**CITY OF FRESNO
DEVELOPMENT AND RESOURCE MANAGEMENT DEPARTMENT**

**CONDITIONS OF APPROVAL
APRIL 19, 2017**

VESTING TENTATIVE TRACT MAP No. 6160

**NORTHEAST CORNER OF THE INTERSECTION OF NORTH COLONIAL AND WEST SAN JOSE
AVENUES**

LEFT ELEVATION - Building 'A'

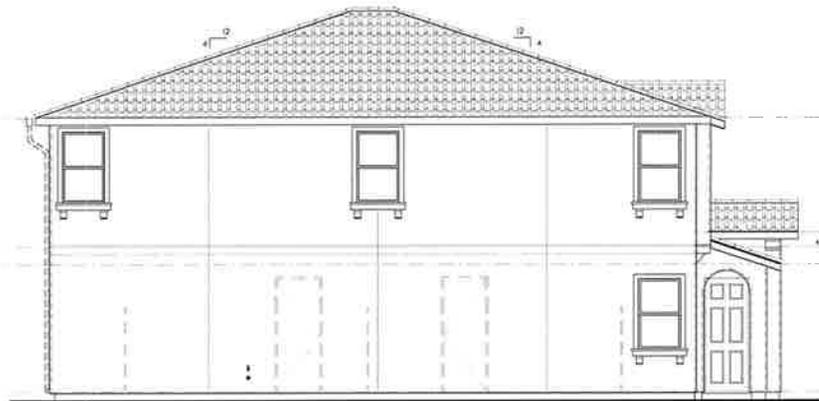
DOES NOT MATCH BUILDINGS #5-6 DOORWAY ON SITE PLAN

(A) RIGHT ELEVATION - Enhanced Street Elevation

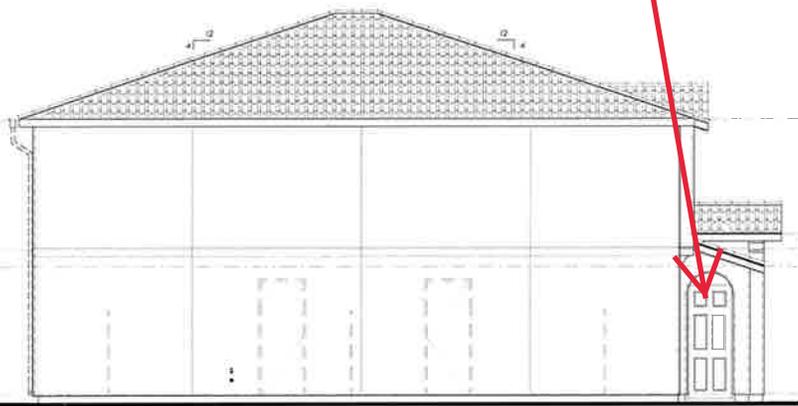
DOES NOT MATCH REVISED SITE
 PLAN FOR BUILDINGS #5-6

Sheet Title
 Landscape Plan

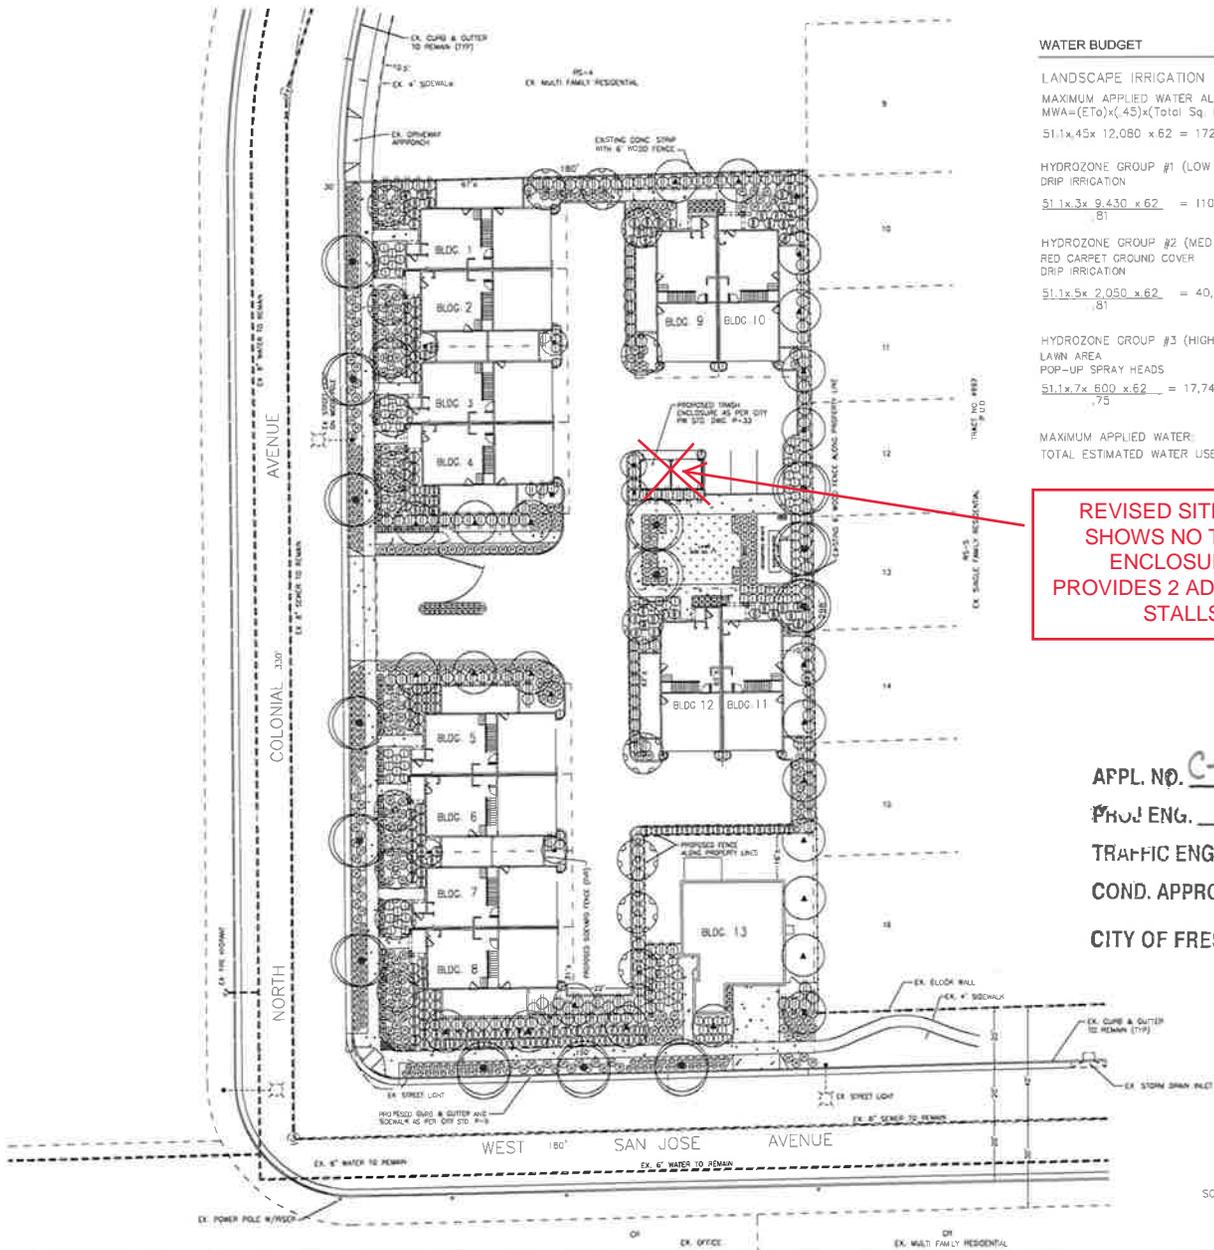
**REVISED SITE PLAN
 SHOWS NO TRASH
 ENCLOSURES
 PROVIDES 2 ADDITIONAL
 STALLS**

SITE PLAN
614 WEST SAN JOSE AVENUE
 APN 417-140-21
 TRACT NO. 6160
 C-16-062

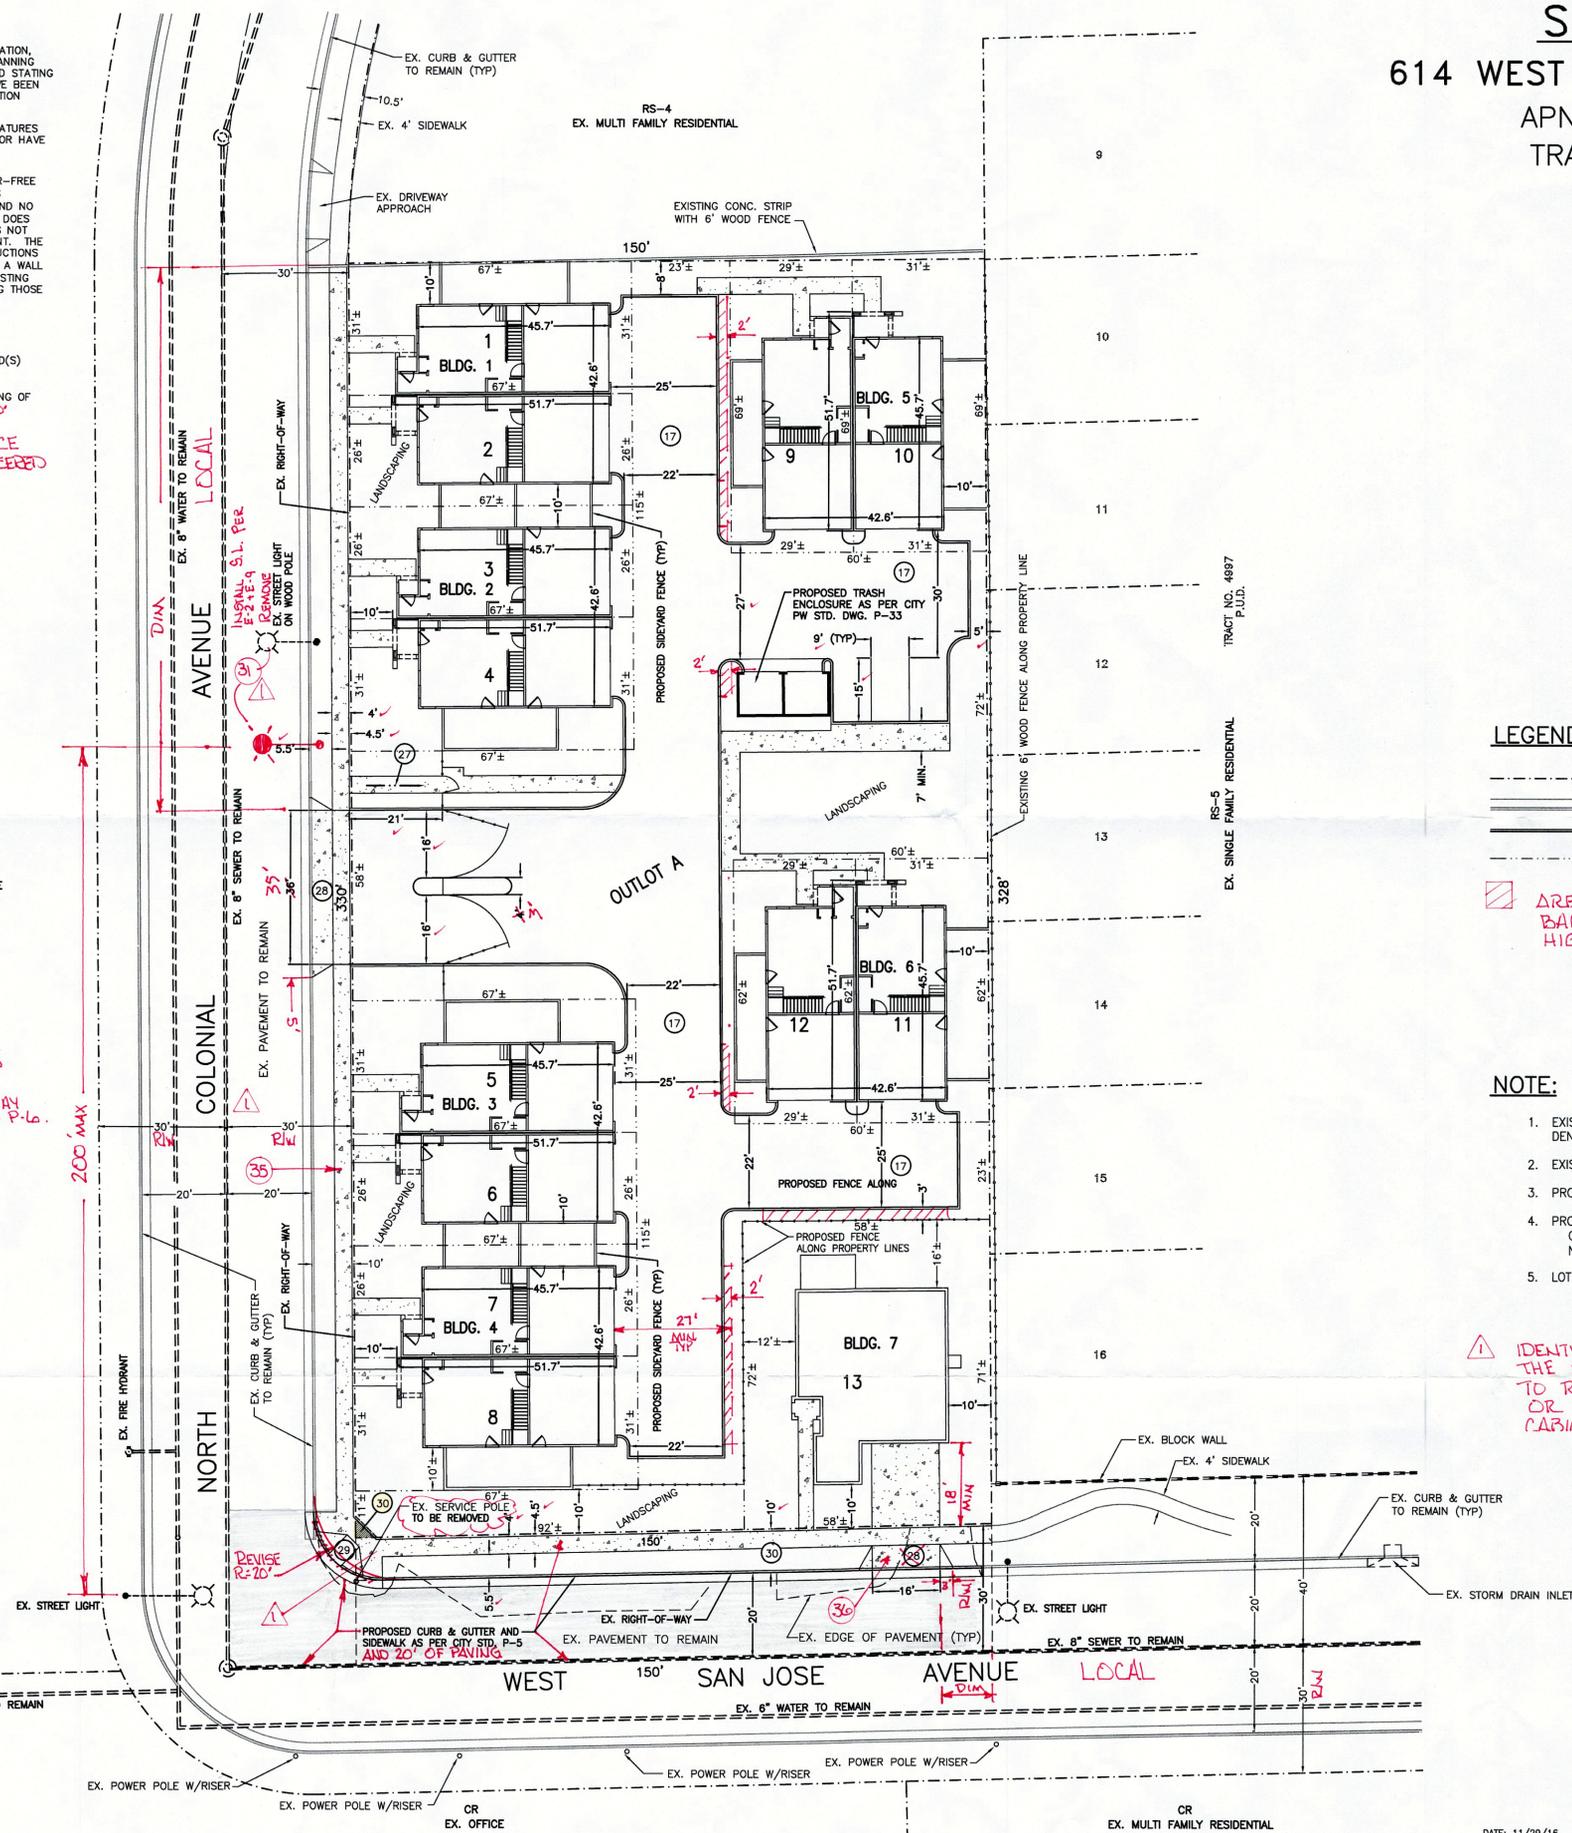
1. Provide a dimension from all proposed drive approaches to the nearest property line.
2. Provide notes as shown in red on C-16-062 **Exhibit "A"**.
3. Identify the required paving along San Jose and the street light along Colonial.
4. Identify all utilities and signage within the street right of way. Specify if to remain, be removed or to be relocated.
5. Revise the curb return radius to R=20' per Public Works Standard **P-26** and coordinate with the corner cut dedication.

- TO BE DEEDED FOR PUBLIC STREET PURPOSES BY THE RECORDING OF TRACT NO. 6160. PRIORITY PERMITS BASED ON E-20 PER P.W. STD. P-20.
- REMOVE (E) STREET LIGHT + REPLACE PER P.W. STD. E-24E-9. ENGINEERED PLANS TO BE SUBMITTED TO TRAFFIC + ENGR. SERVICES.
